SB-10043468-2953

Improved Transverse Torque Rod Bracket Workstar Severe Duty Models

Workstar-Severe Service Models - Latin America Markets

All models up to VIN: 672707

Modified/improved Bracket Identification marking (circled in yellow)

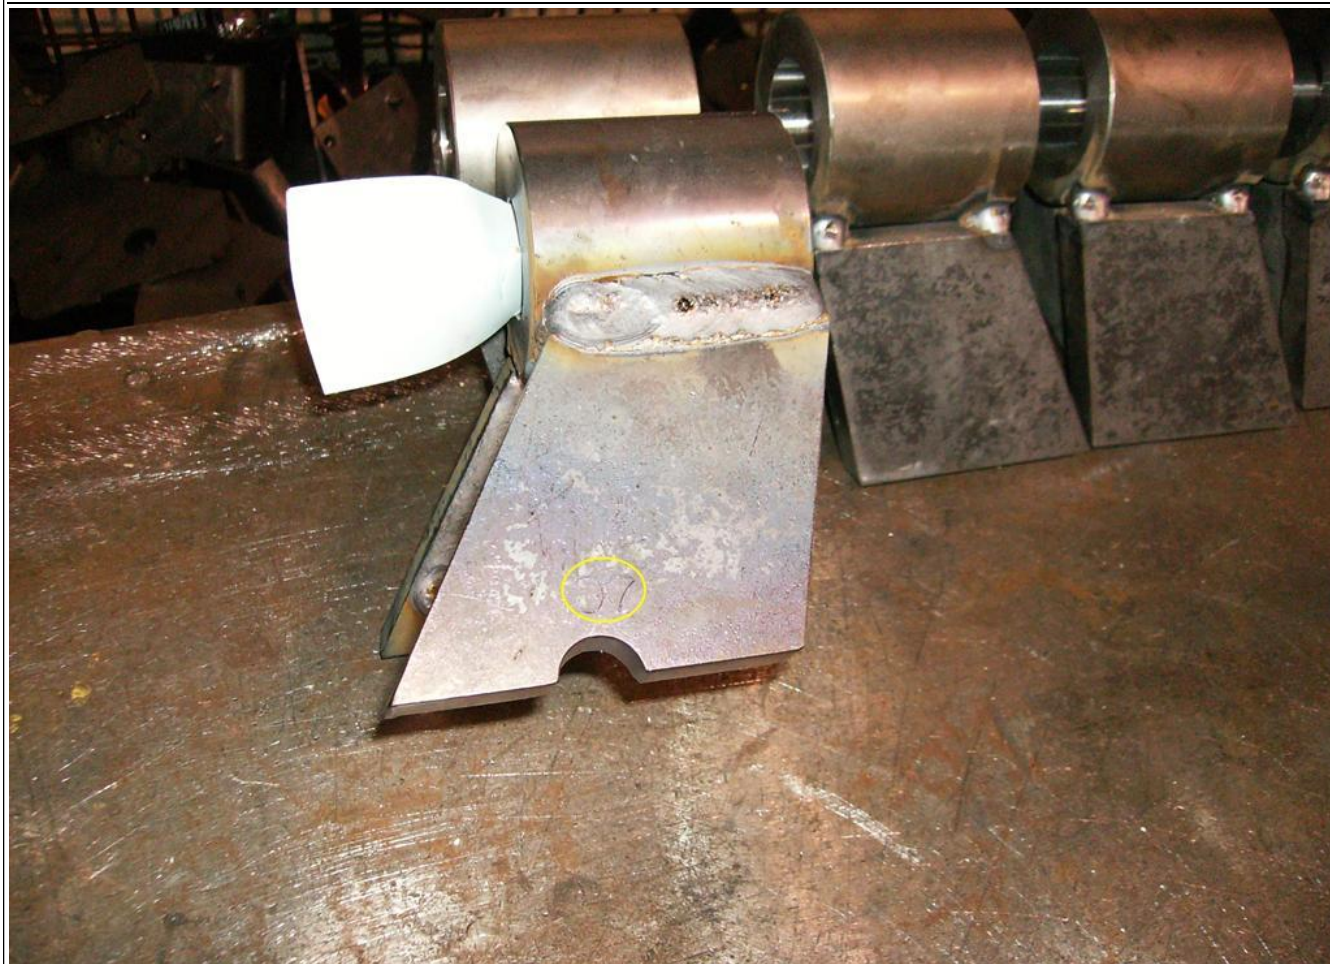
The transverse torque-rod tower bracket on rear axle(s) could fail under severe duty applications.

An improved and stronger transverse bracket has been released to address this concern. The improved part can be quickly identified by a marking on the side of the bracket (see picture).
